From: Langdon, Robert <RLangdon@scsengineers.com>
Sent: Wednesday, May 25, 2022 10:09 AM
To: Lauridsen, Keld B - DNR
Cc: MThun@harters.net; Omernik, Jared
Subject: RE: Applebys Auto Salvage (BRRTS # 03-60-305128)
Attachments: 220425_Lauridsen_Appleby's Auto Salvage Redev PCM and MMP_R1.pdf; Harters Oostburg Utility Plan.pdf

Post-Closure Modification with Materials Management Plan

Former Appleby's Auto Salvage
W2578 Holland Lima Road
Oostburg, Wisconsin
BRRTS #03-60-305128

Subject: Post-Closure Modification with Materials Management Plan
Former Appleby's Auto Salvage
W2578 Holland Lima Road
Oostburg, WI
BRRTS Activity #03-60-305128

Figure 1 – Proposed Facility Site Plan with Residual Soil and Groundwater Contamination

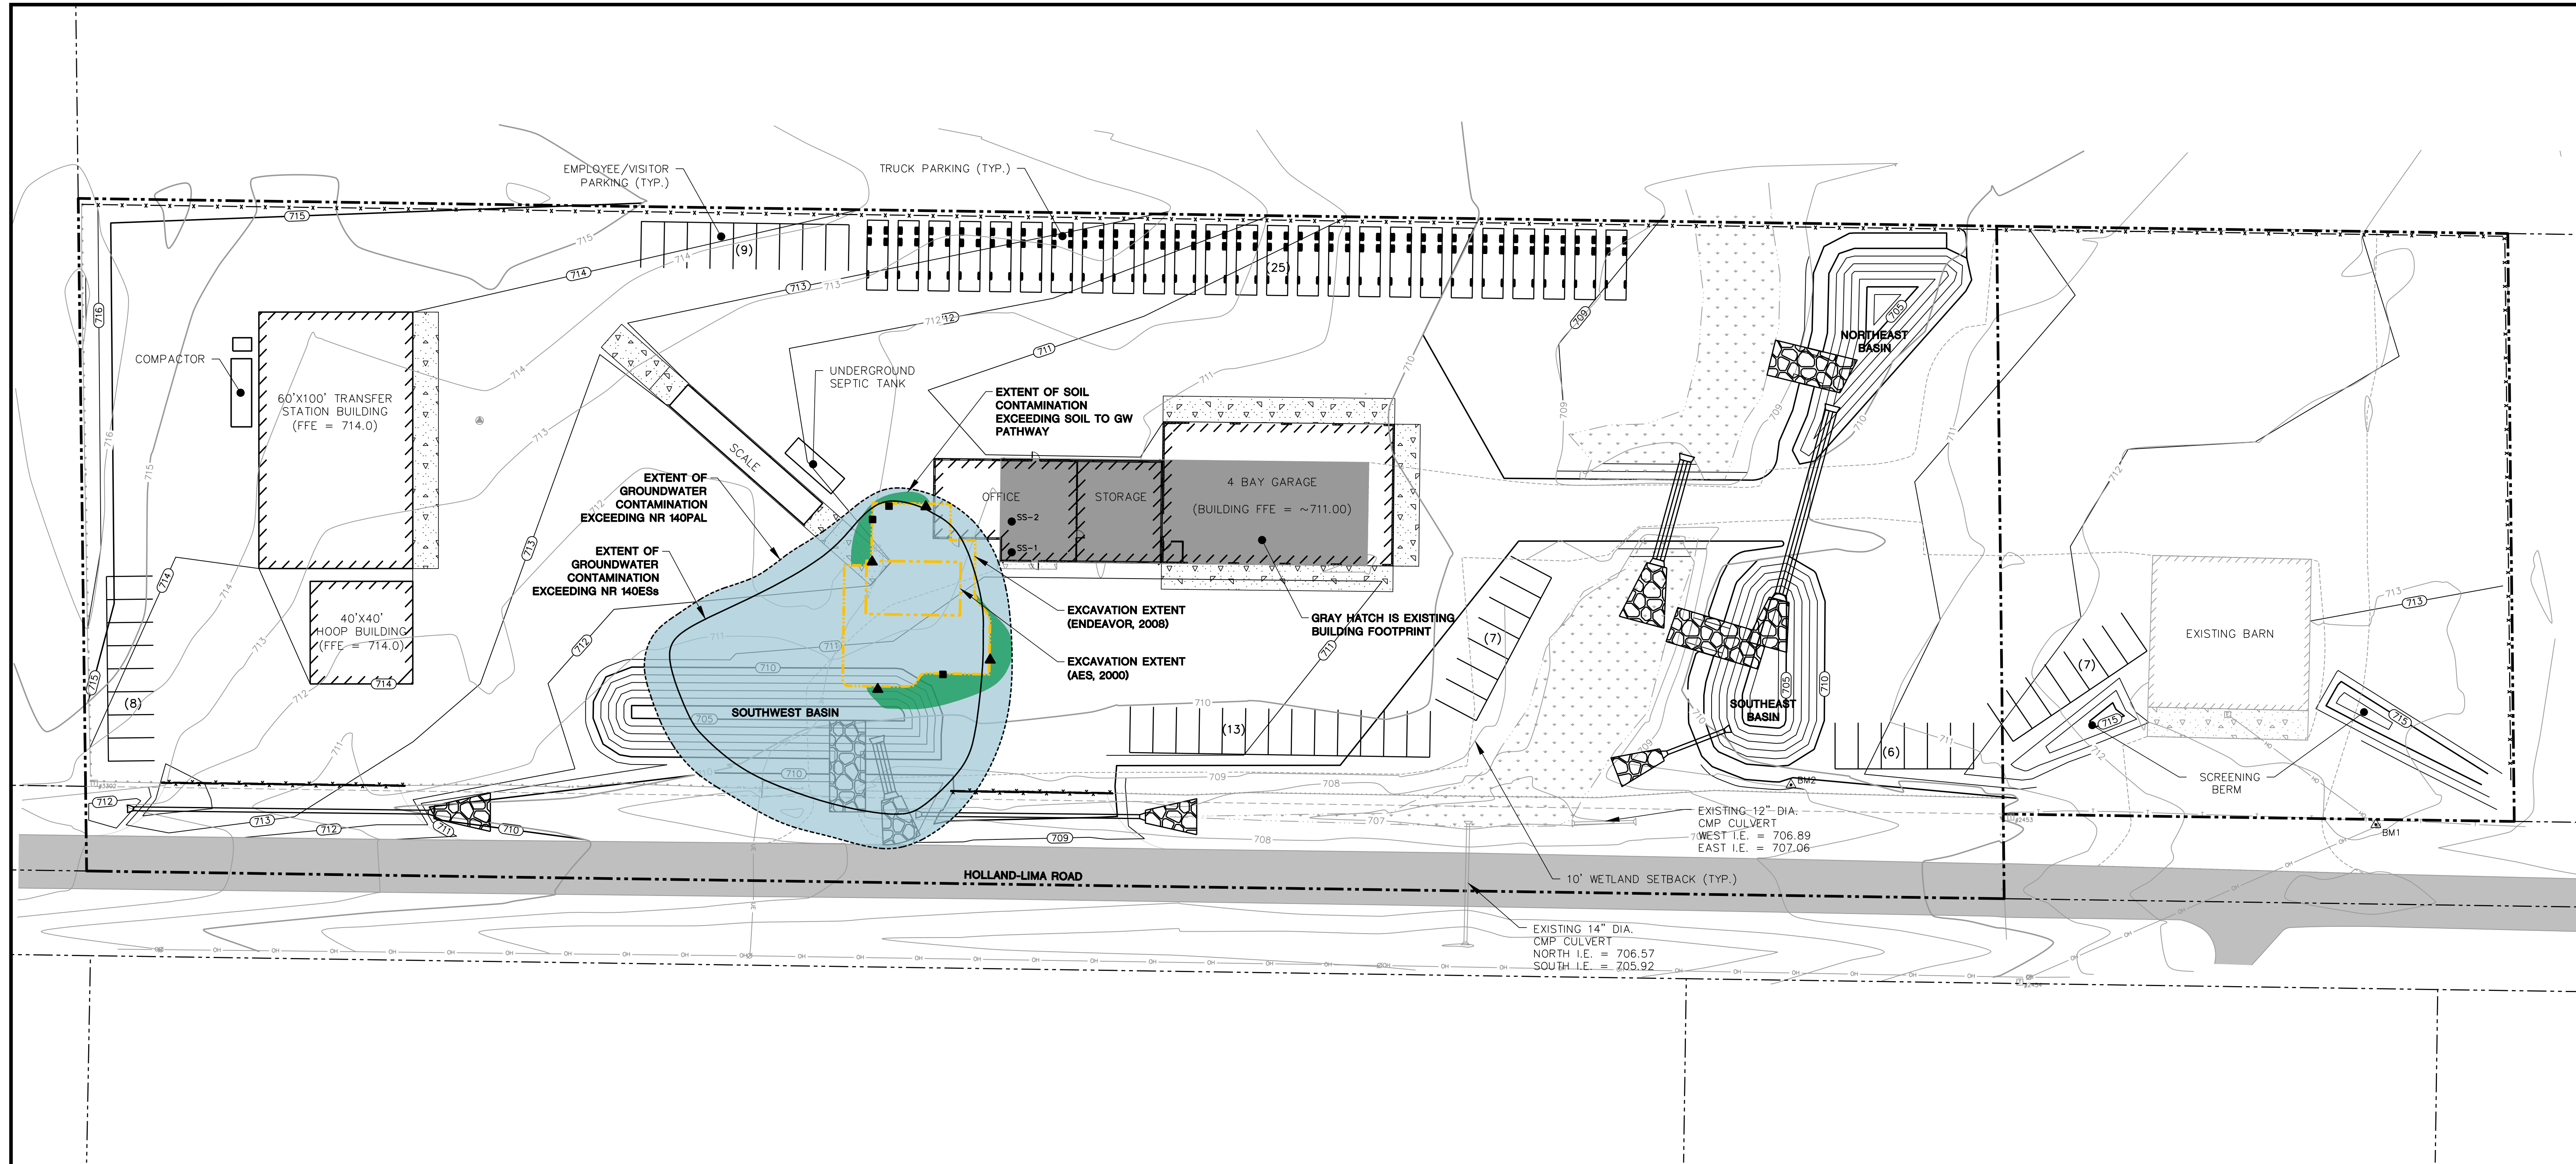
Class I soils are primarily clay and possibly remedial excavation backfill (assumed to be sand and/or gravel) in contact with impacted groundwater. Class I soils are present within the two regions shown on **Figure 1** but also include any soil excavated during redevelopment construction activities and exhibiting petroleum staining or odor that may be present beyond these areas.

On March 15, 2022, two sub-slab vapor ports (SS-1 and SS-2) were installed near the residual soil and groundwater impacts, as shown on **Figure 1**. Sample ports and sampling equipment were tested for leaks prior to sampling. A sample was drawn from each port using laboratory-supplied Summa canisters. Samples were submitted with completed chain-of-custody documents to Pace Analytical laboratory in Minneapolis, Minnesota, for analysis of petroleum VOCs (PVOCs), naphthalene, and 1,2-dichloroethane (1,2-DCA). Laboratory analytical results are provided in **Attachment A**.

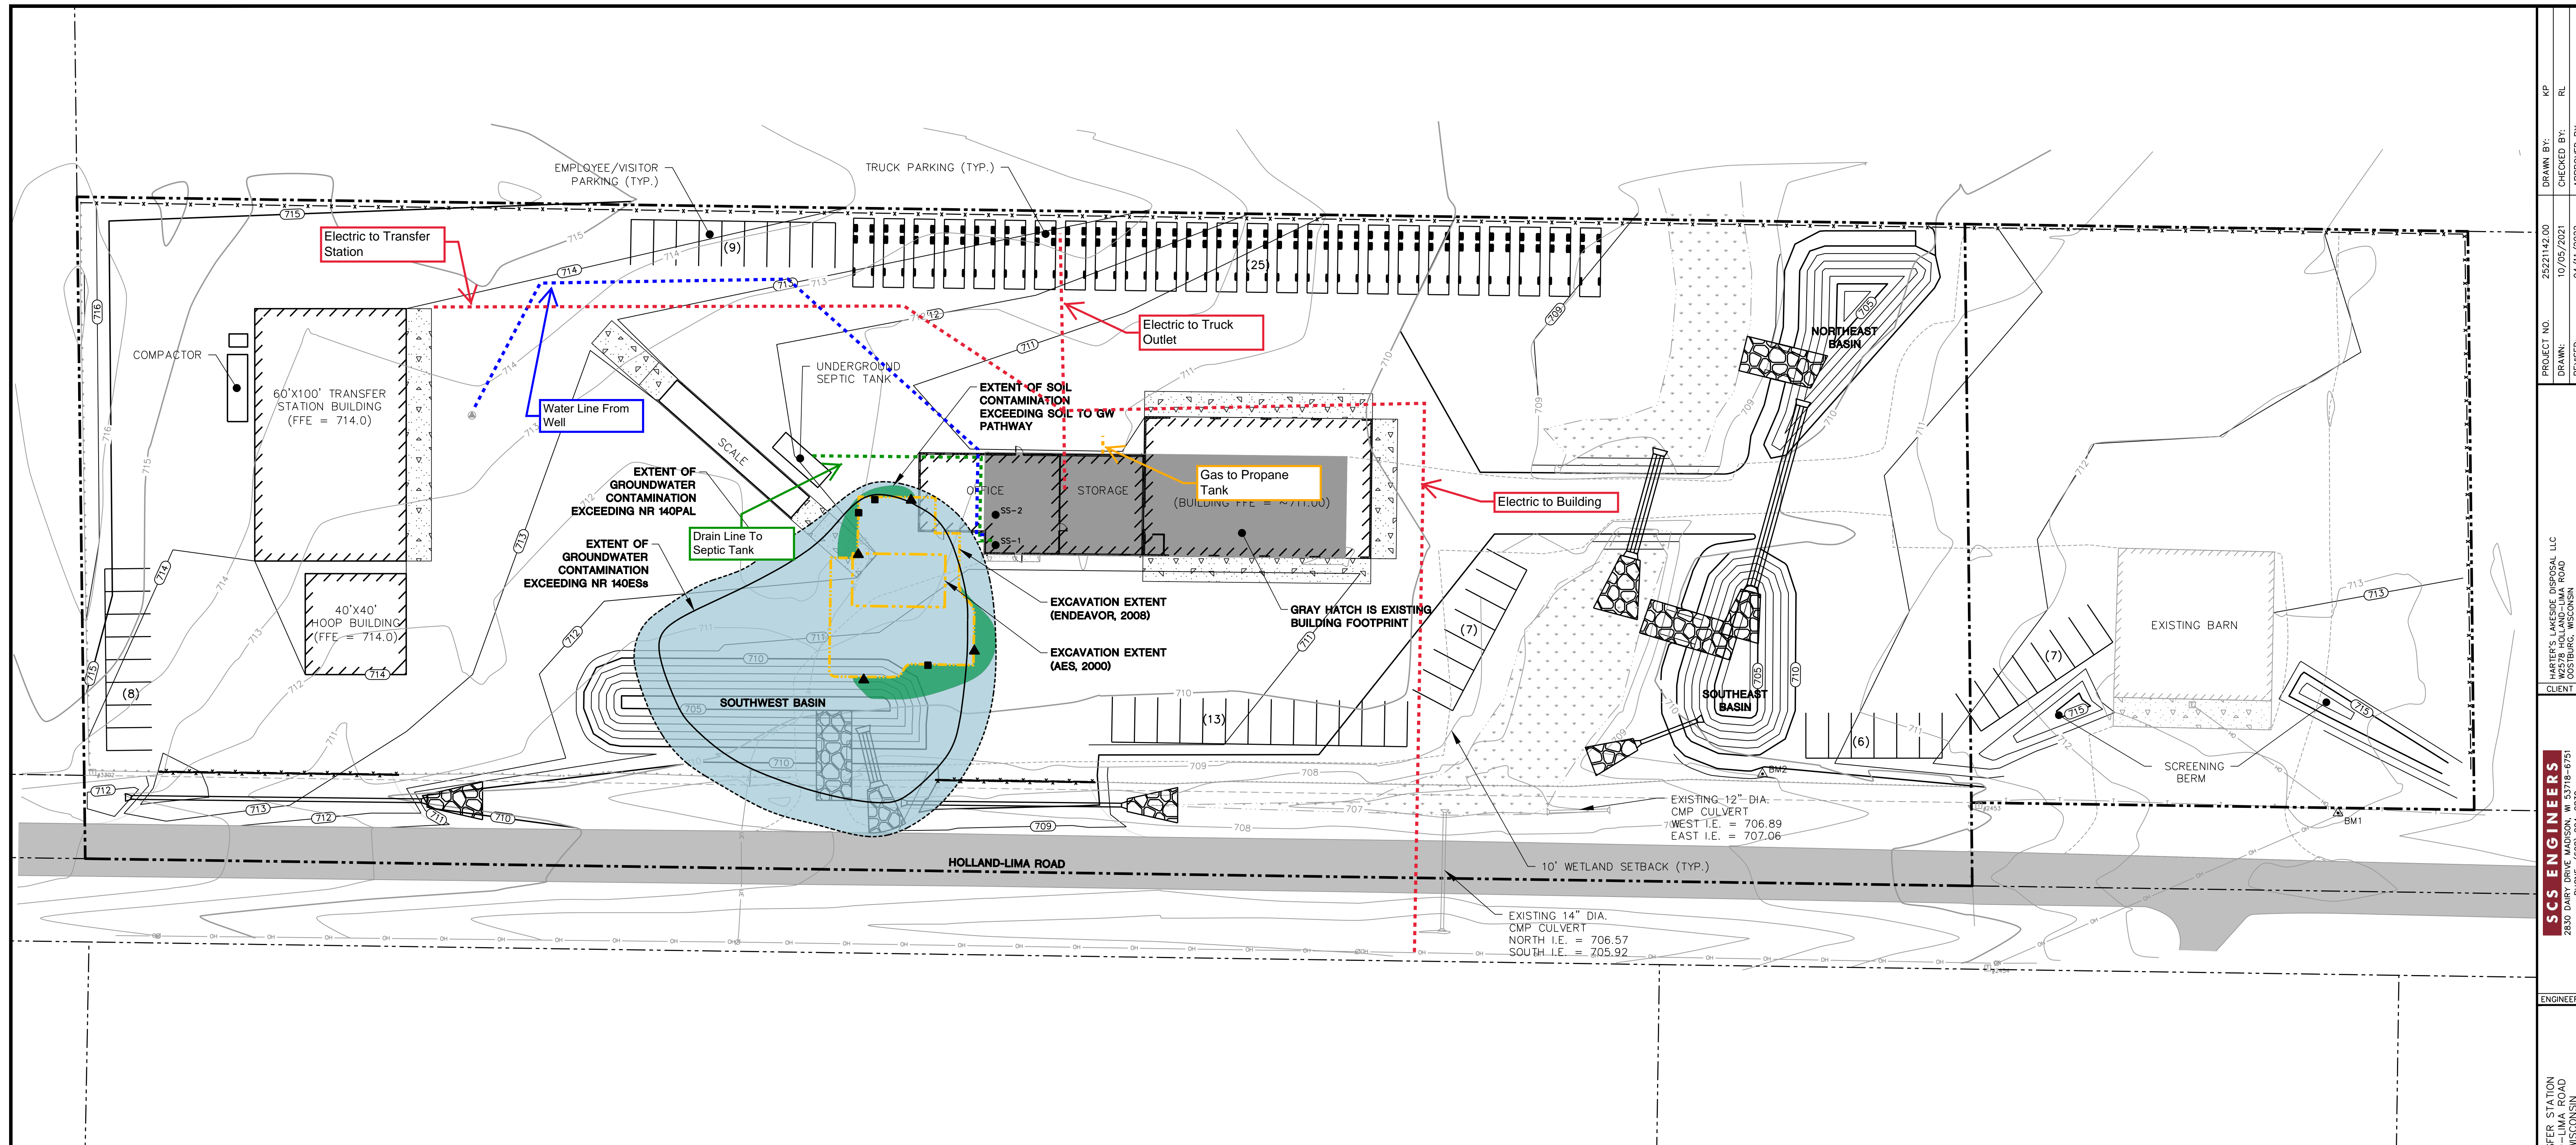
1. NR 712 signature page - see attached revised letter with signature page.
2. Utilities – see attached map with utilities.
3. Stormwater - The southwest basin will be constructed with a Type A pond liner (used for sites with the highest potential for groundwater pollution) in accordance with WDNR's technical standard 1001 for Wet Detention Ponds. The liner will be constructed of clay so would not be influenced by hydraulic pressure like a geomembrane, but will reduce infiltration into the underlying soils. It will also limit the migration of groundwater into the basin.

Would you have some time today to discuss my questions from last week regarding the post-closure modification at the above site?
